Signal Detect Level for 400GBASE-ZR - supporting comment #247 on 802.3cw D2.1

IEEE P802.3cw

CI 156 SC 156.5.4 P 88 L 40 # 247

Figure 156-5—Black link example configuration for specifying n DWDM channels

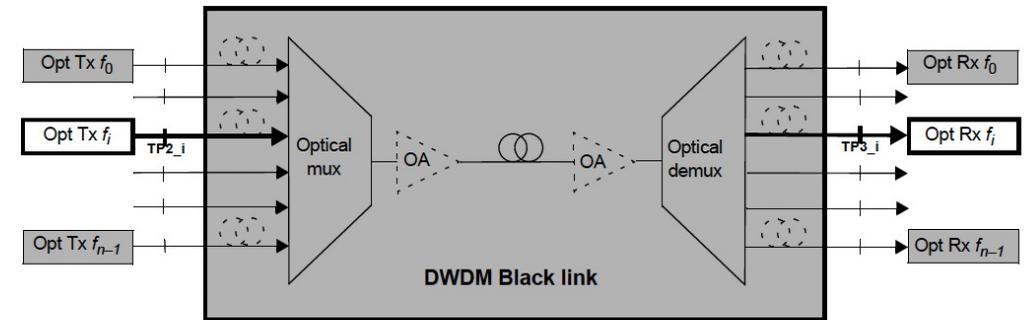
For 400GBASE-ZR, an appropriate signal detect level can be defined. At a 29dB OSNR, for our highest allowable Rx Power, the accumulated noise would be -20dBm assuming a 100GHz Demux BW, for a 26dB OSNR the value accumulated noise would be -17 dBm.

SuggestedRemedy
Add a SIGNAL_DETECT level to indicate OK and FAILED, with a value of ≤ -17 dBm indicating FAIL.
